Subject: AP1000 COL Standard Technical Report Submittal of APP-GW-GLN-018, Revision 0

APP-GW-GLN-018, Revision 0
“Alternate Steam & Power Conversion”

TITLE: **ALTERNATE STEAM AND POWER CONVERSION DESIGN**

Alternate Steam and Power Conversion Design

Figure 10A.4.7-1 (Sheet 2 of 4)

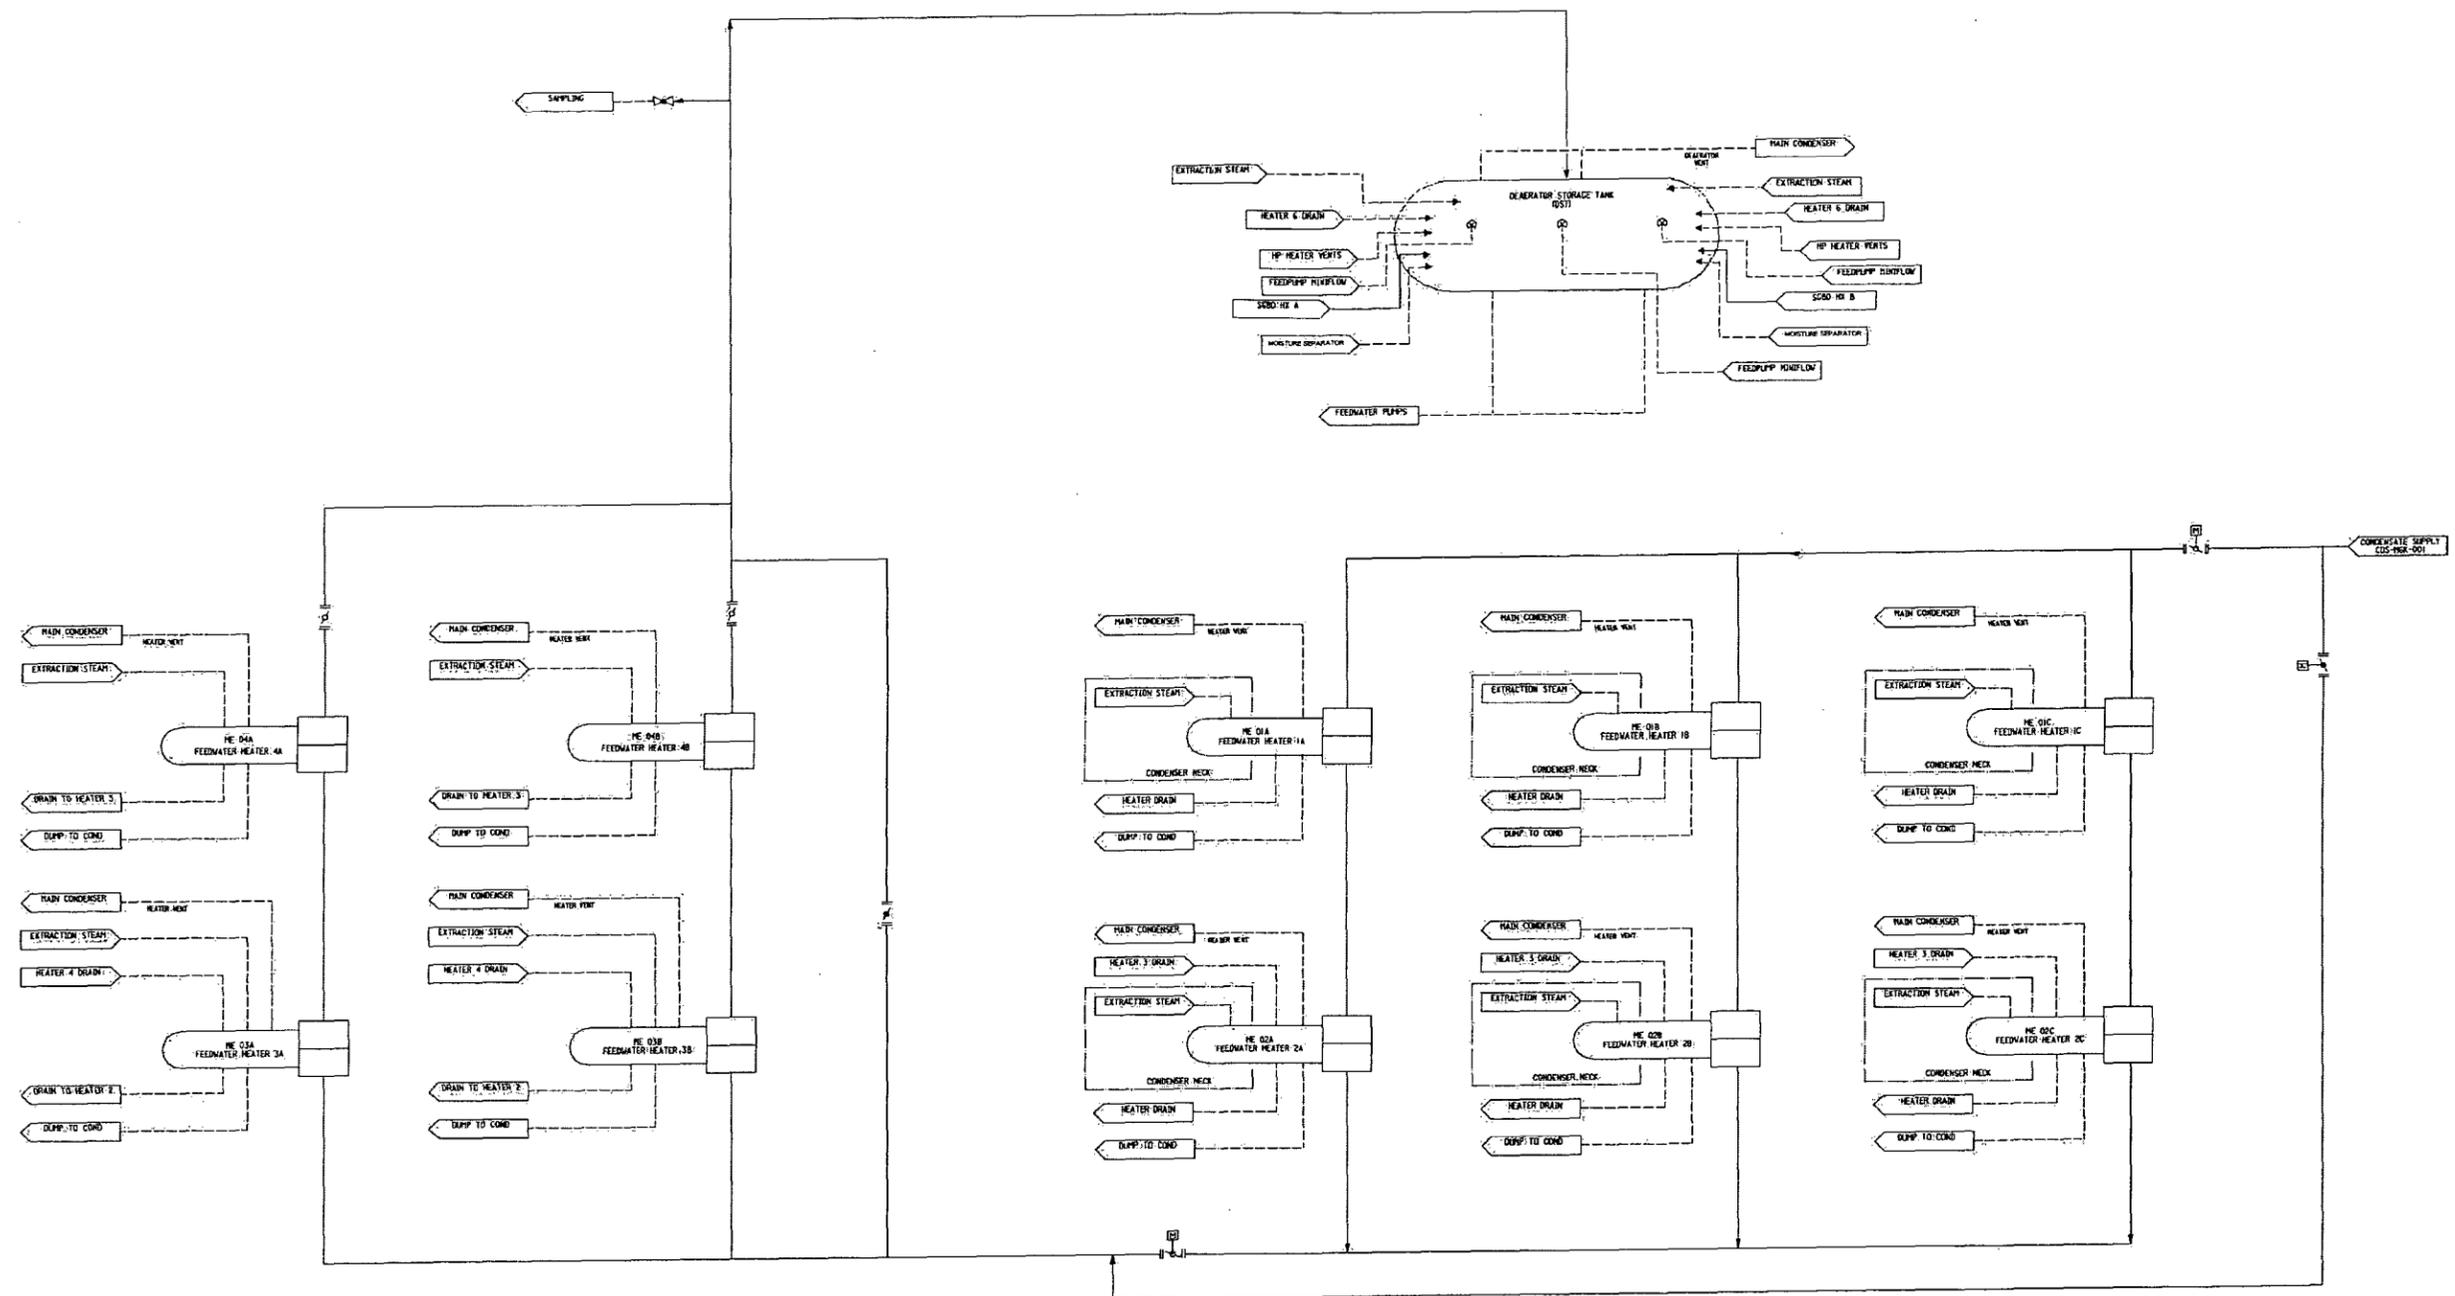
The main condenser is part of the AP1000 condensate system (CDS). The condensate system is described in subsection ~~10~~10A.4.7 and shown in Figure ~~10~~10A.4.7-1. Classification of equipment and components is given in Section 3.2. Table 10.4.1-1 provides main condenser design data.

The condensate and feedwater system is shown schematically in Figure ~~10.4.7-1~~10A.4.7-1, and in Figure 10.3.2-1. Classification of equipment and components is given in Section 3.2.
